**BROWNS FERRY**

**EXAM 2002-301**

**BROWNS FERRY NUCLEAR PLANT (BFN) - COMMENTS TO NRC WRITTEN EXAMINATION QUESTIONS**

**ENCLOSURE 1**

Reference: 3-730E938, Sheet 8, Electrical diagram for Residual Heat Removal System, Circuit B relay logic. OPL171.044, TP-23, Hot License Certification training for the Residual Heat Removal system (RHR), Transparency #23, 2-FCV-74-67 Control Circuit.

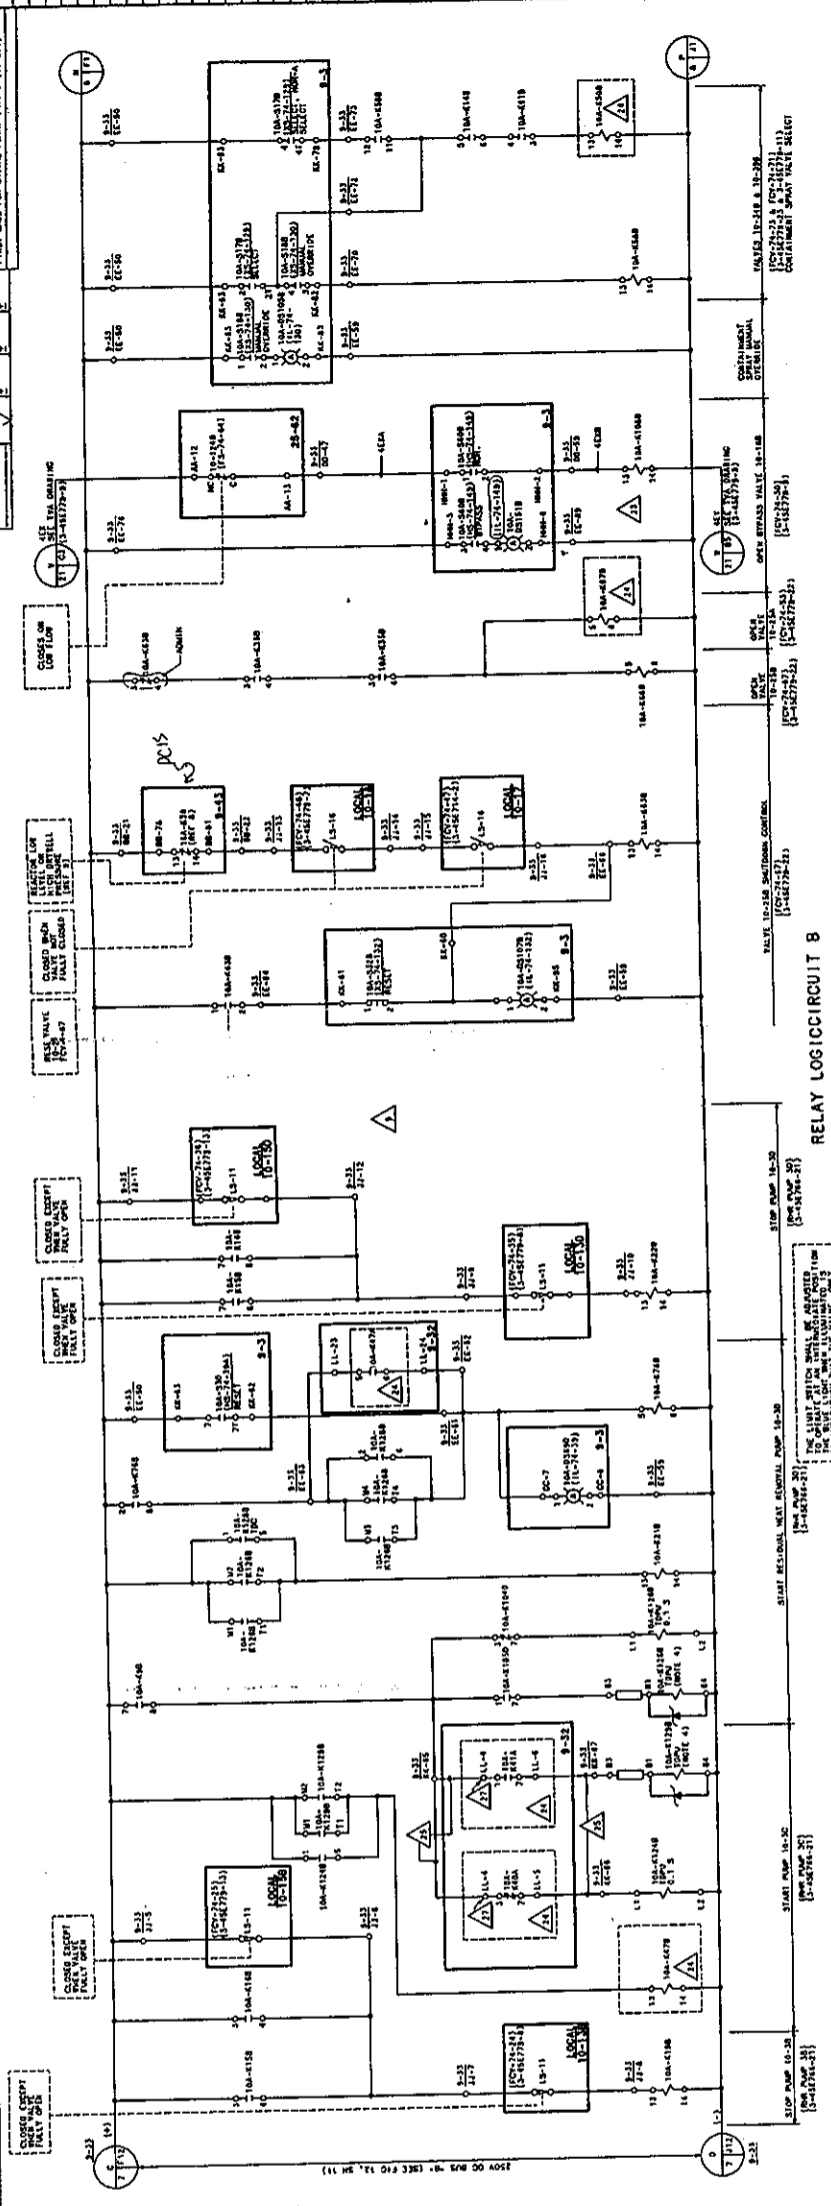
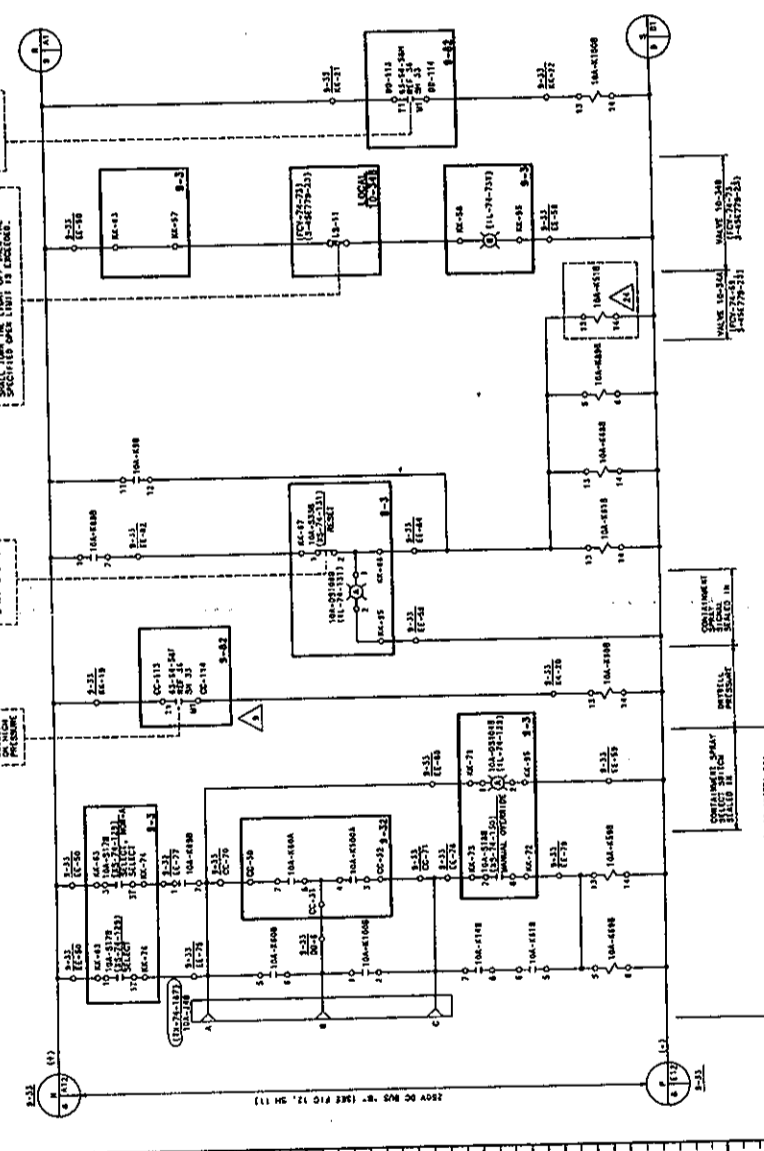
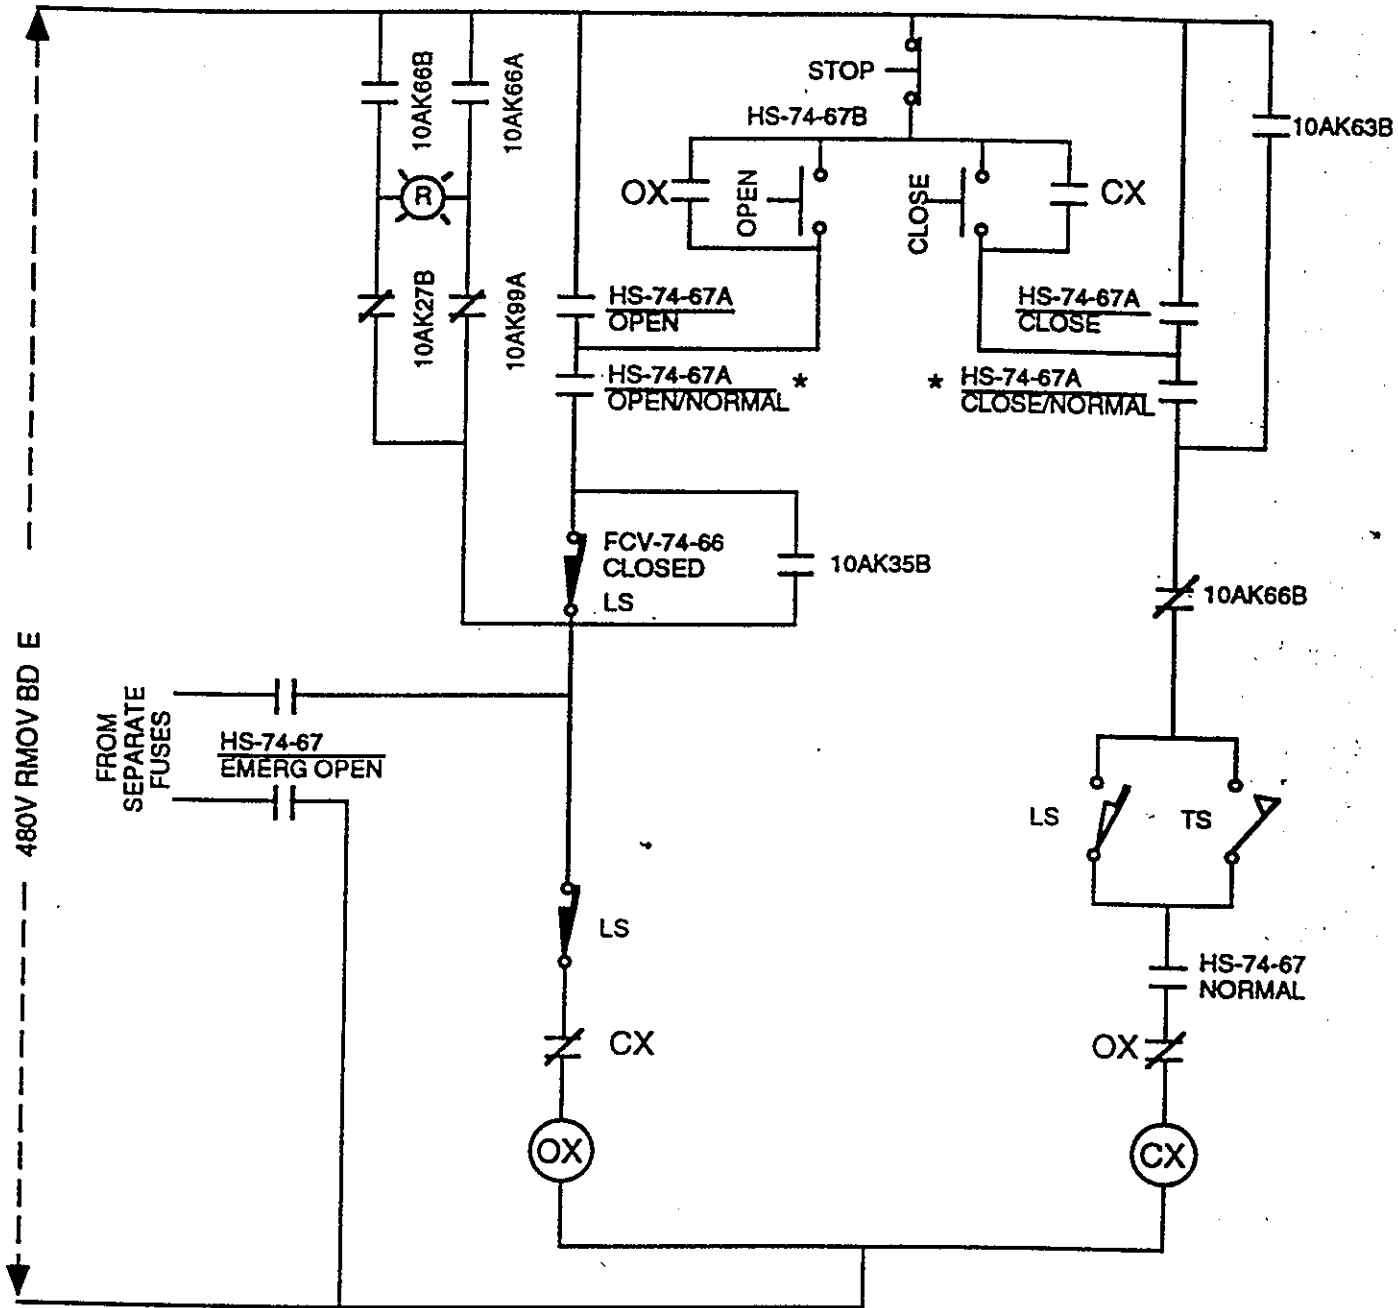
In reviewing the question, we believe both "A" and "C" are correct. The basis is as follows:

"A" and "C" are operationally the same correct answer.

In order to manually re-open 3-FCV-74-67 following a Group 2 Isolation signal, at least one of the two Shutdown Cooling Suction Valves must be closed and the Isolation Signal must be reset.

The only method at BFN to reset a Group 2 Isolation Signal to the 3-FCV-74-67, RHR SYS II LPCI INBD INJECT VLV, is to use the RHR SYS II SD CLG INBD INJECT ISOL RESET pushbutton and answer "A" implies that this reset method has been performed.

**Proposed disposition: Accept either "A" or "C" as correct**

### DG KW vs KVAR LOADING

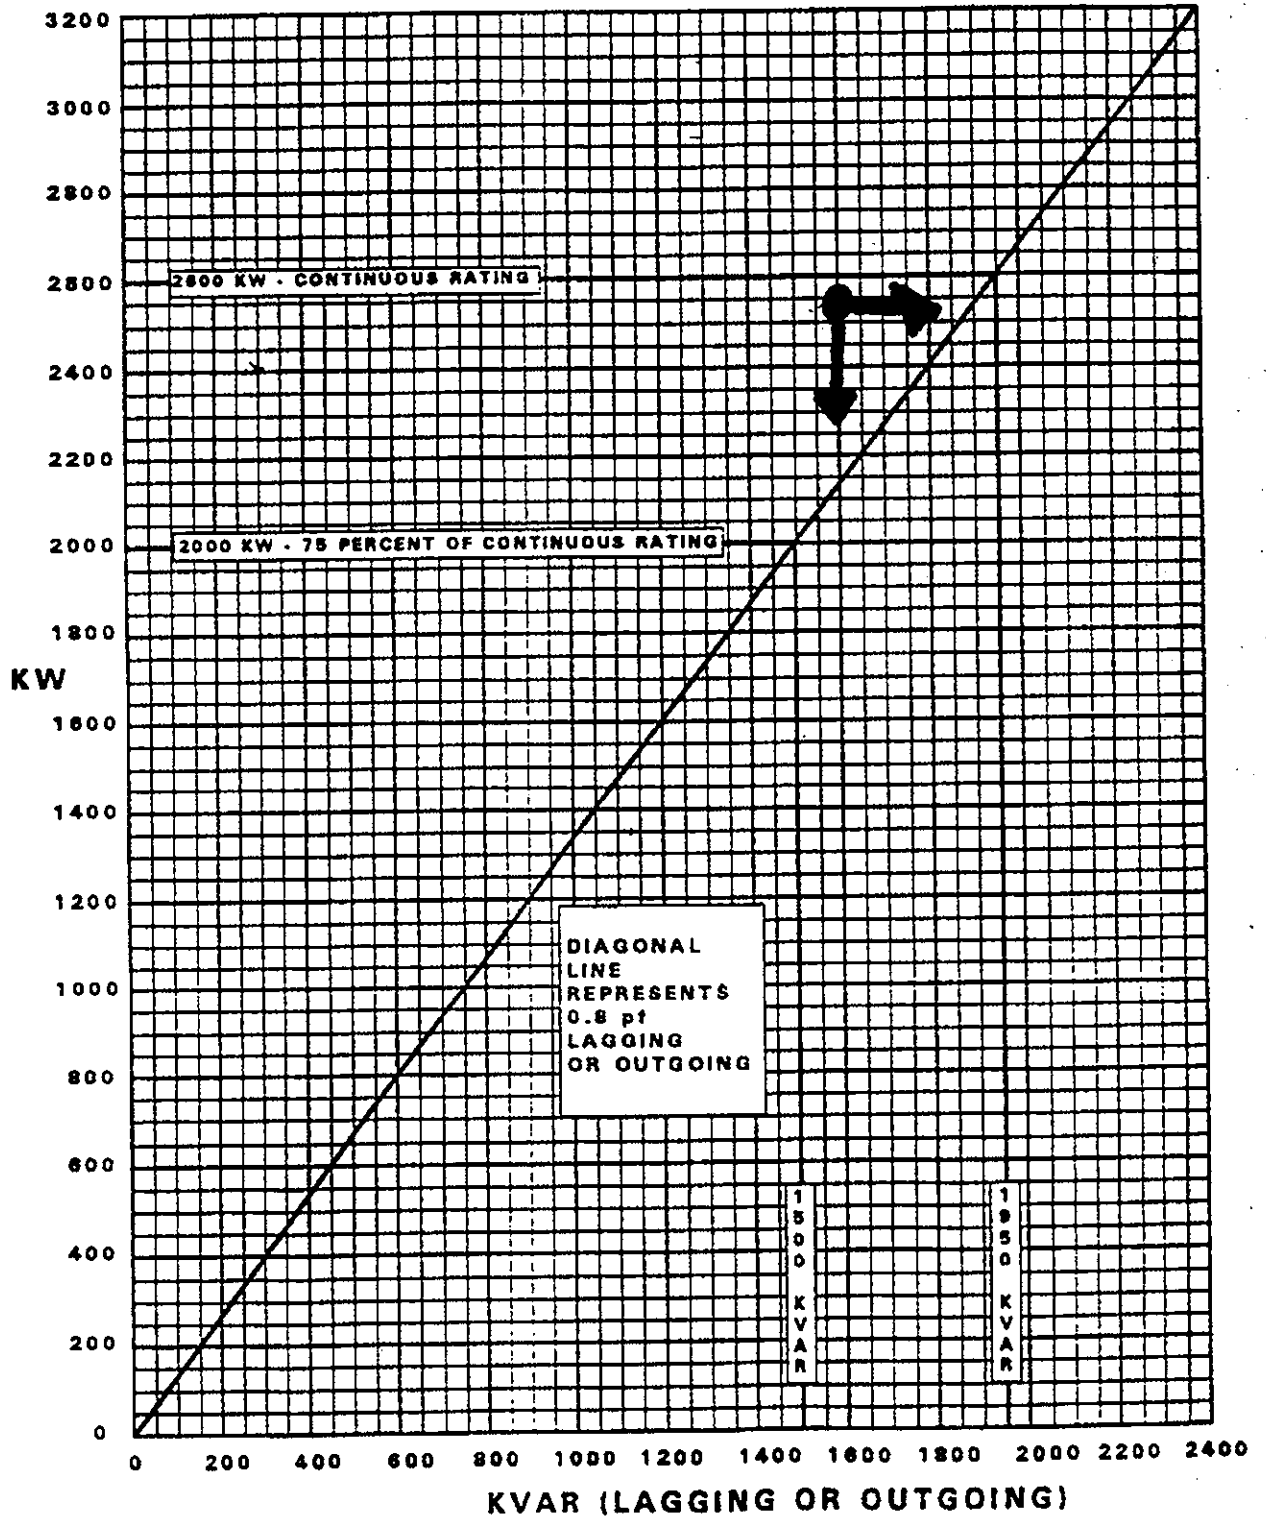
In reviewing the question, we believe both "A" and "C" are correct. The basis is as follows:

"A" and "C" both reflect correct responses for these generator conditions. In accordance with OI-82, Standby Diesel Generator System, Step 8.1.12, the required 0.8 power factor may be achieved either by placing the Voltage Regulator Switch to the RAISE position or by placing the Governor Control Switch to the LOWER position in order to reach the diagonal line on Illustration 1, DG KW vs KVAR LOADING.

Since the question only asks for a correct required action (and not the supporting reason), both "A" and "C" are correct.

**Proposed disposition: Accept either "A" or "C" as correct**

**MECHANICAL INSTRUMENTS AND CONTROLS**

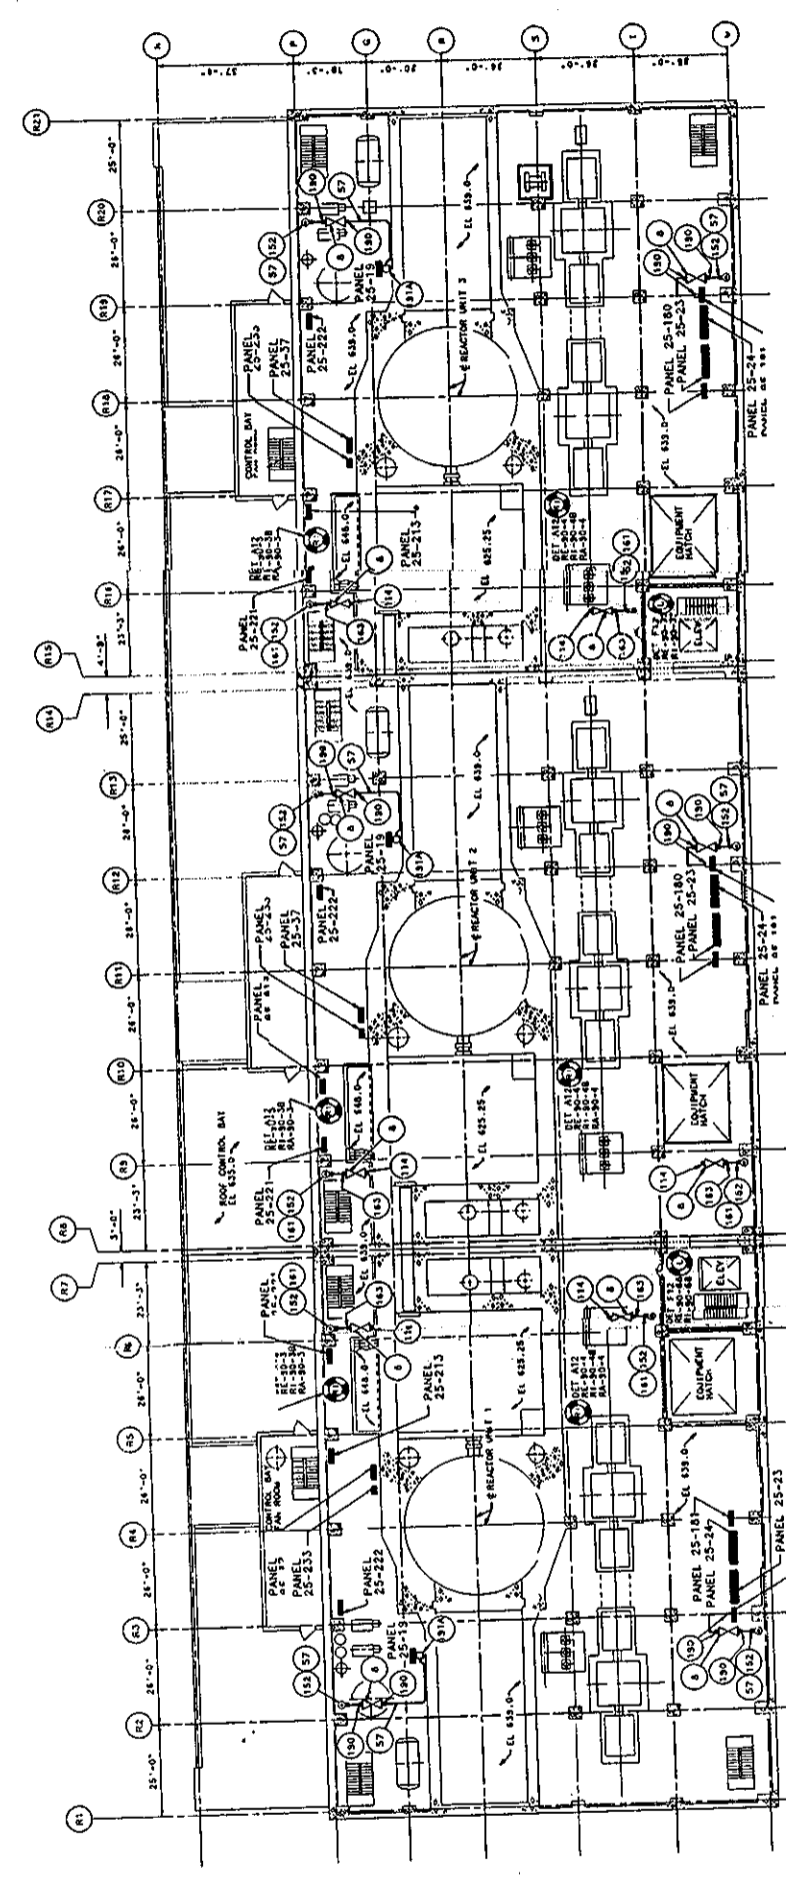
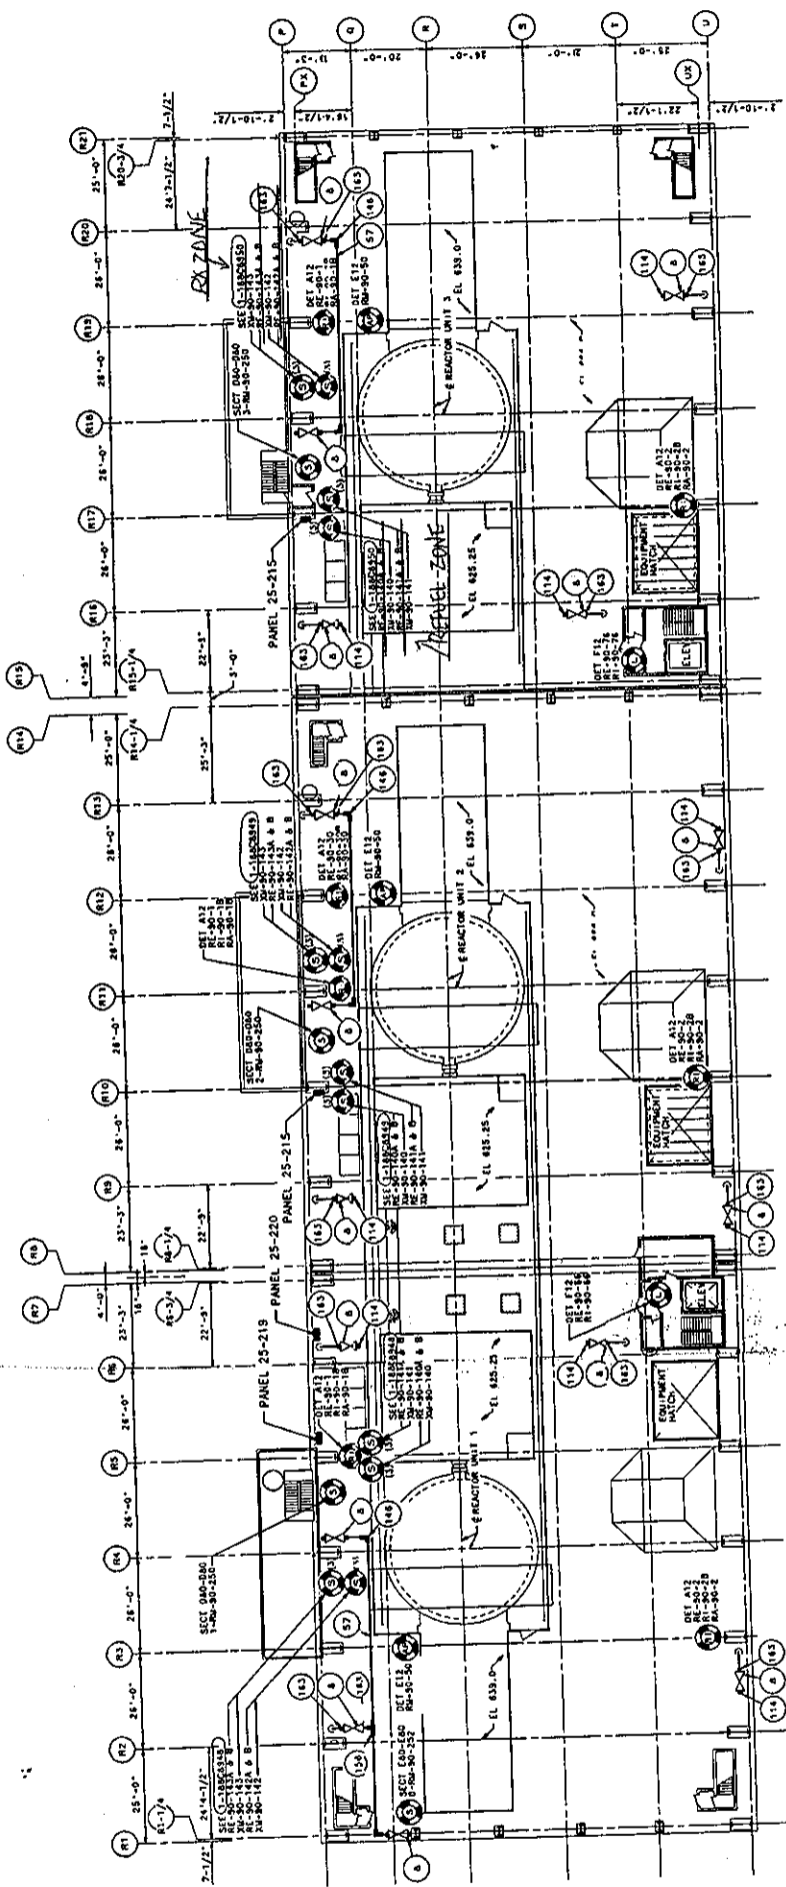
In reviewing the question, we believe both "A" and "B" are correct. The basis is as follows:

There is a high probability that this fuel handling accident would have also resulted in a Reactor Zone Isolation signal. The Reactor Zone HVAC Exhaust Radiation Detectors are physically located on the refuel floor in close proximity to the Refueling Zone HVAC Exhaust Radiation Detectors which was the cause of the REFUELING ZONE EXHAUST RADIATION HIGH alarm. Both Reactor and Refuel Zone HVAC radiation monitors have the same trip set-point. If this setpoint is exceeded, which is evidenced by the fact that the Refueling Zone is isolated, then it could be reasonably concluded that the Reactor Zone should have isolated. The Reactor Zone isolation is an automatic action that should occur if the Reactor Zone Exhaust Radiation Monitor setpoint is exceeded. (see attached drawing for relative location of detectors).

Since the stem of the question does not provide radiation monitor equipment identification numbers (e.g., 3-RM-90-250); actual local dose rates; or Reactor Zone HVAC status, a trained operator would conclude that a high radiation condition exists at the Reactor Zone Radiation detectors. Therefore, verification of a Reactor Zone HVAC Isolation is a correct action.

**Proposed disposition: Accept either "A" or "B" as correct**
